Consolidated Draft Briefing Reports

Assessment and opinions on specific
topics related to Aurora Energy's June
2020 Customised Price Path application

Produced for the Commerce Commission

November 2020

Figure 12: SONS / totex

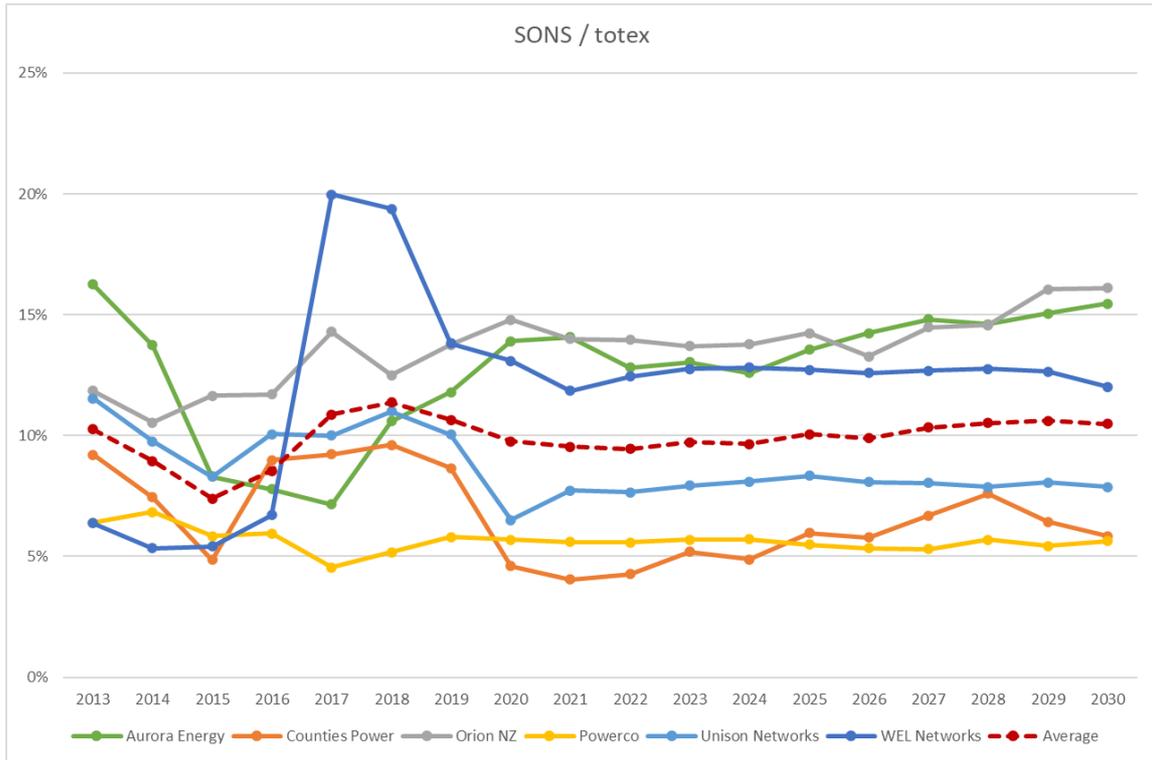
Figure 12 shows the same results as Figure 5—Aurora’s SONS opex exhibits an increasing trend that is high relative to its peer distributors. Only Orion NZ’s ratio of SONS opex to totex is comparable to Aurora’s.

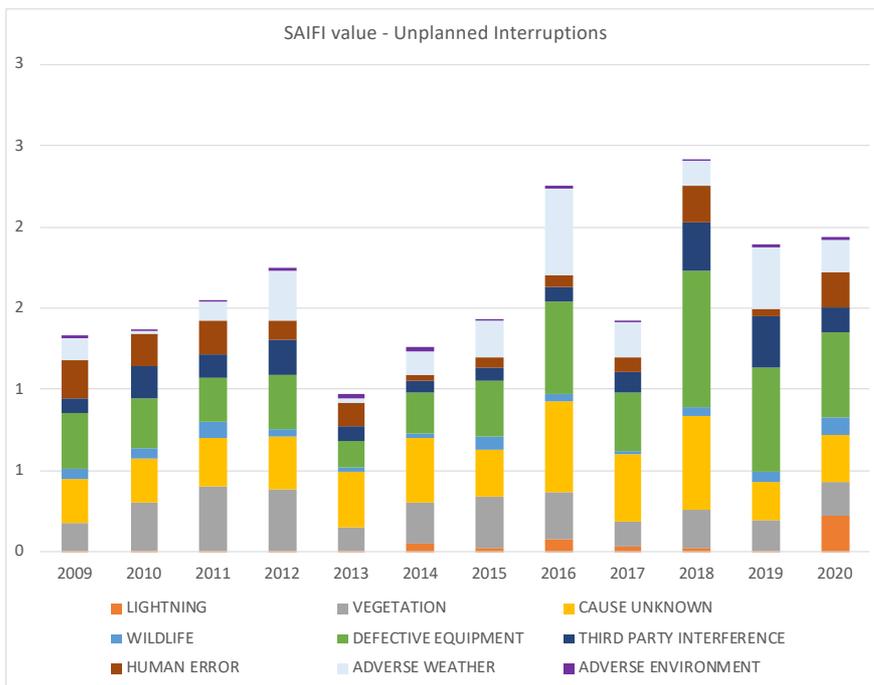
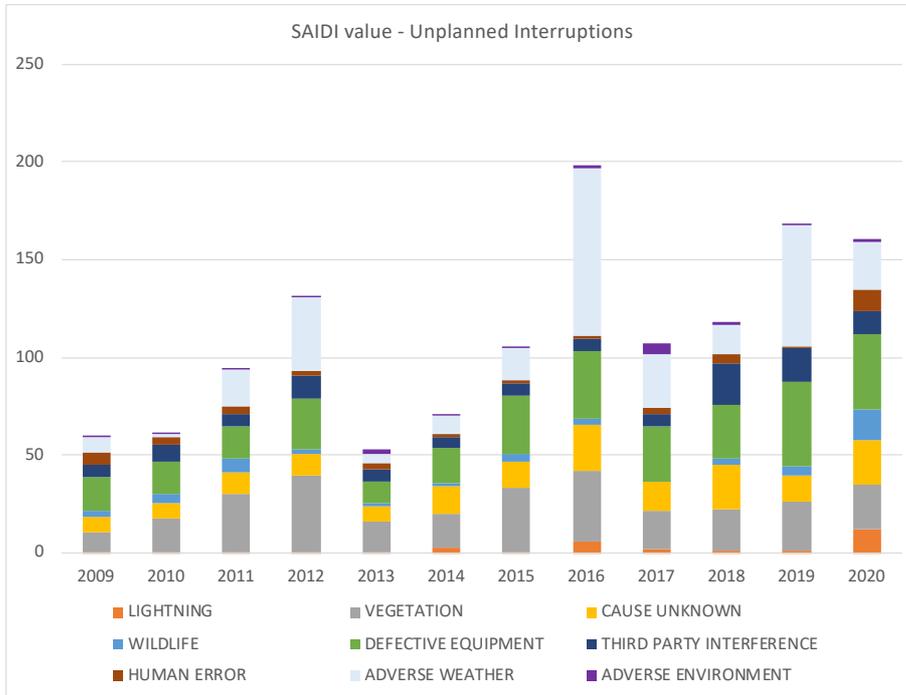
The profile of Aurora’s historical performance for SAIDI and SAIFI (see charts below) suggests a repeating four year pattern of deteriorating performance followed by a sharp improvement, followed by another three years of deterioration before another sharp correction. Whilst we could speculate on the reasons for this, it is beyond our scope to undertake detailed analysis. However, the fact that this pattern is present suggests that taking the three highest SAIDI and SAIFI years, as Aurora has done, as the basis for setting the limit would not reflect the historical trend and be likely to overstate future SAIDI and SAIFI.

In our opinion, Aurora’s choice of the average of the last three years is not appropriate. Taking a 4-year average would have captured both the most recent reliability of the network and historical trends in reliability performance.
